# CITY PLAN COMMISSION STAFF REPORT

Chatham Ave Self Storage

## Plan Conditions, Corrections, & Suggestions Report

Case Number: CD-CPC-2024-00196

SHEET  
E101

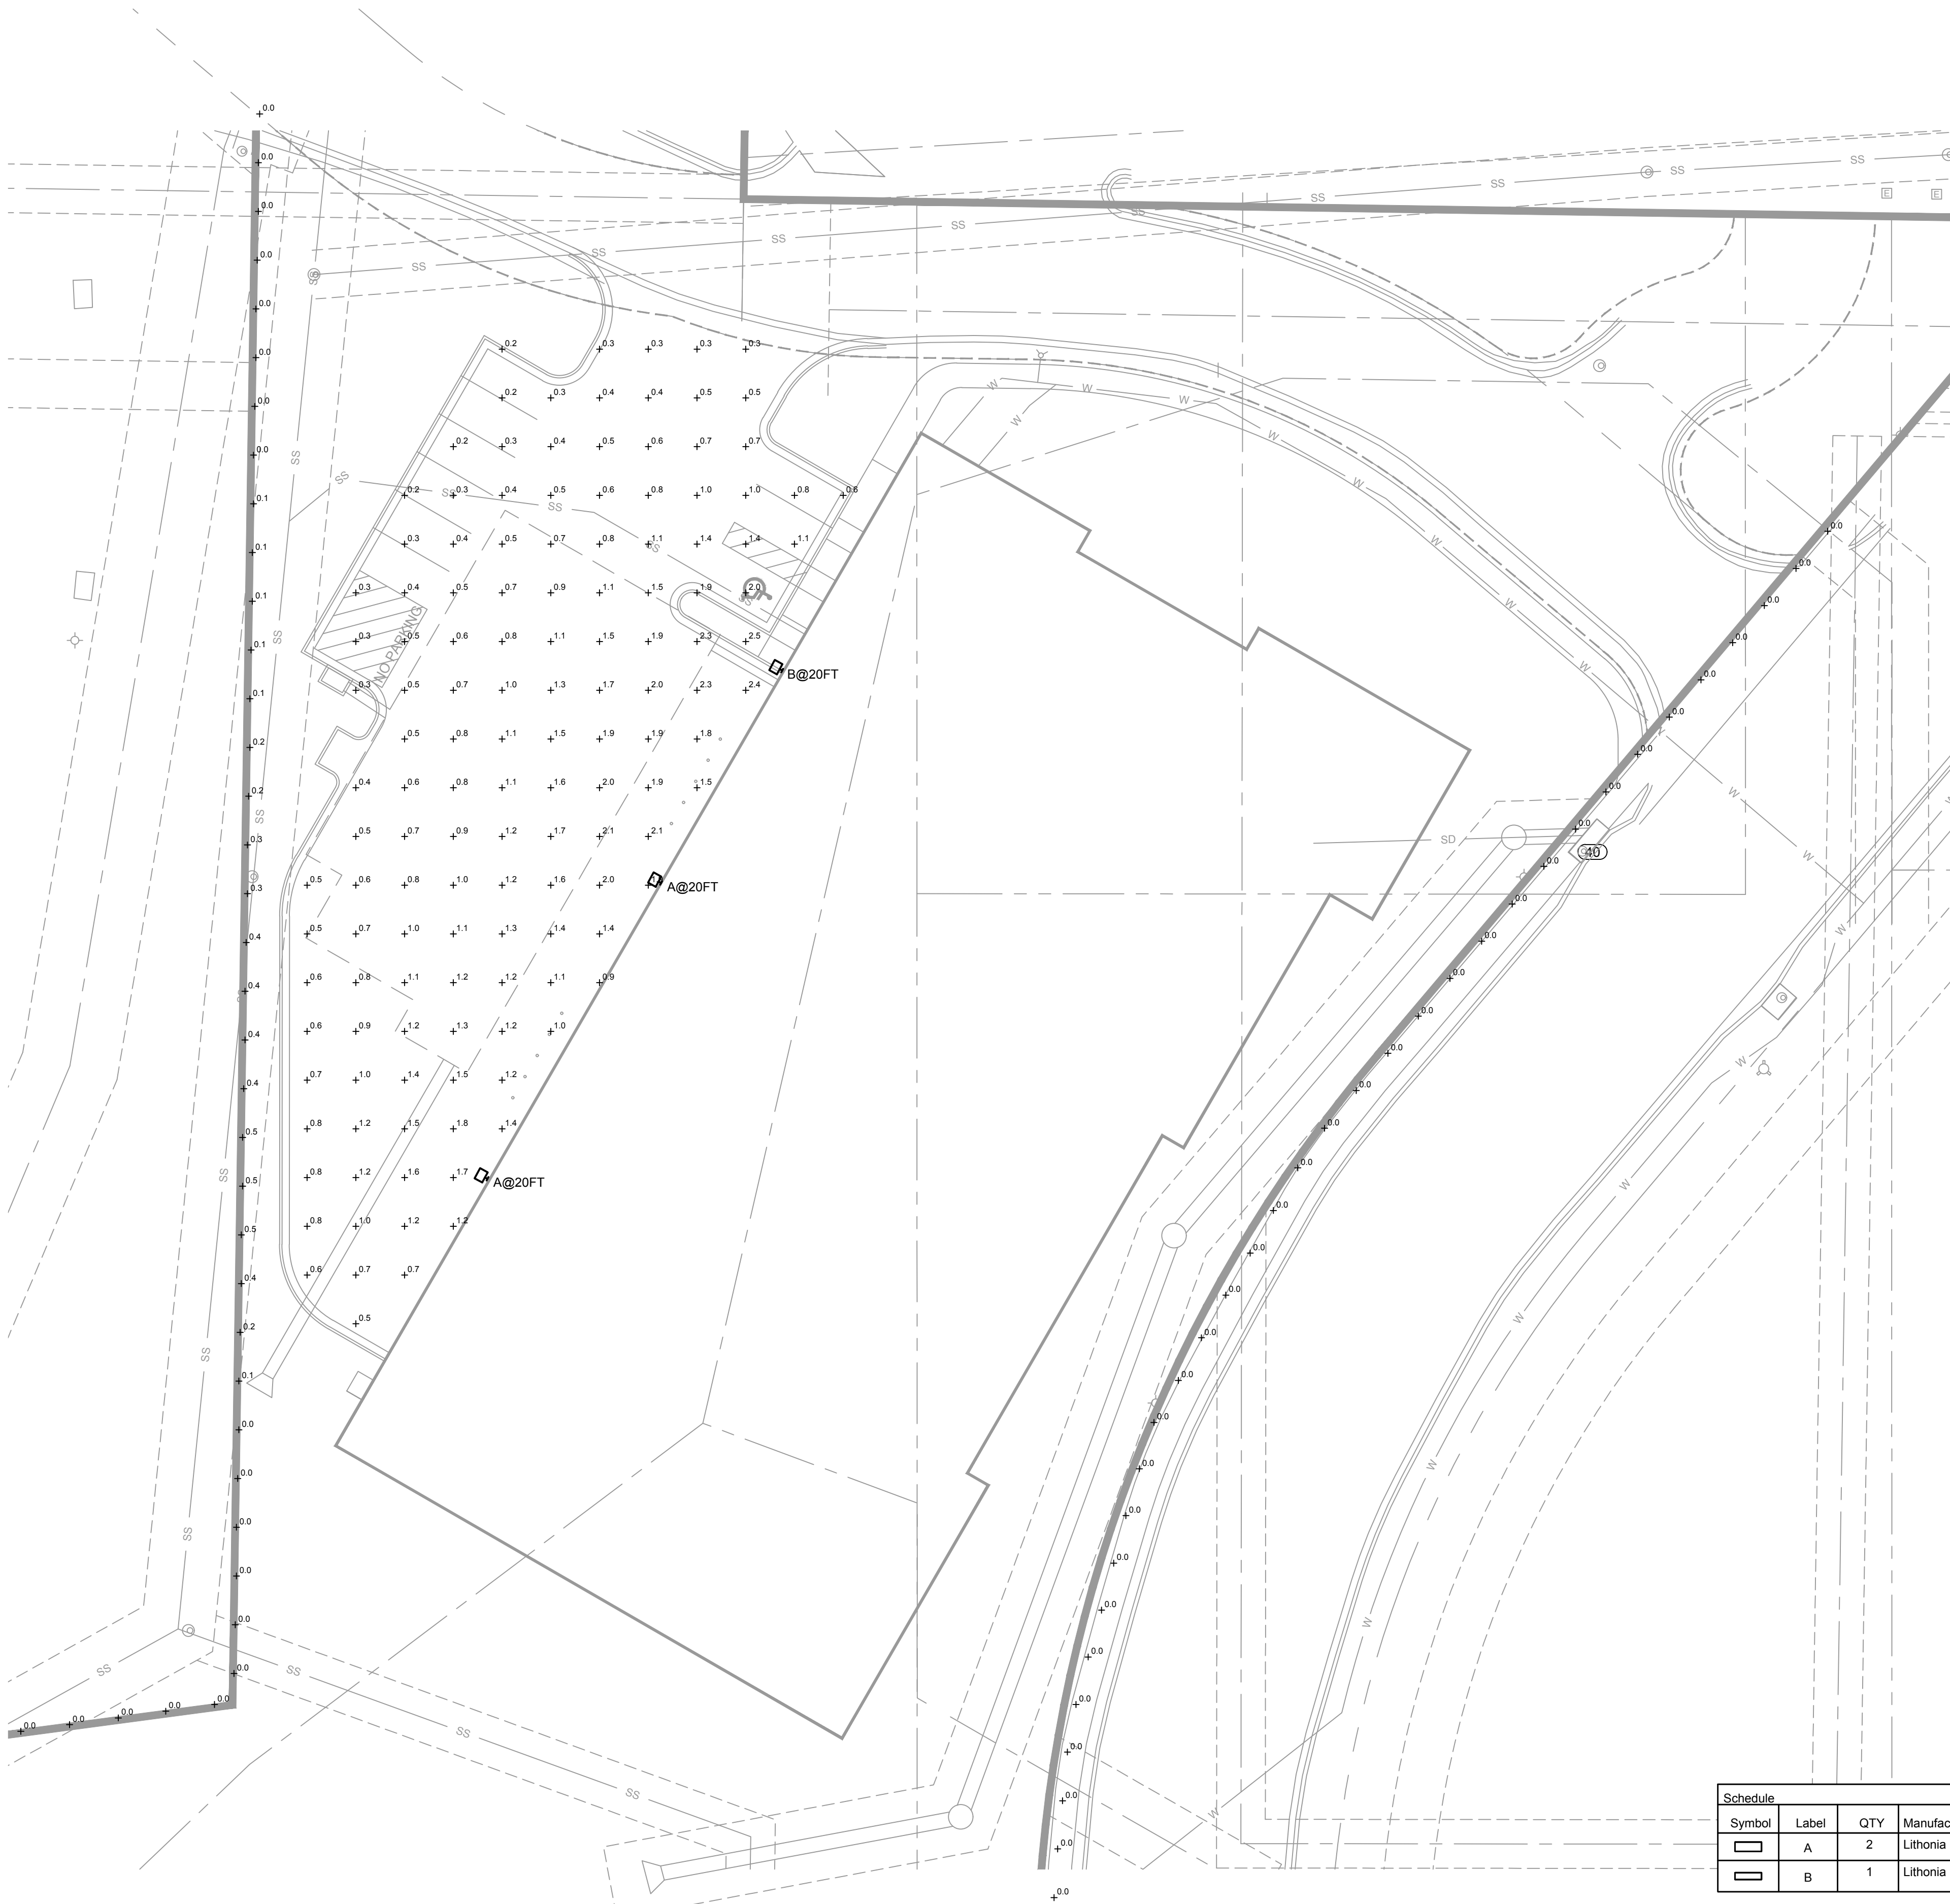
5. Consider changing light fixtures to increase illumination of the parking lot. The illumination Engineering Society (IES) standard for parking lots is an average maintained foot-candle of 3 with the average to minimum ratio to be 4:1 (updated 1/23/2025). (1/21/2025)
6. Dumpster screening needs to be raised 6 inches to 1 foot from the ground on at least one side if solid screening materials are proposed (updated 1/23/2025). (1/21/2025)
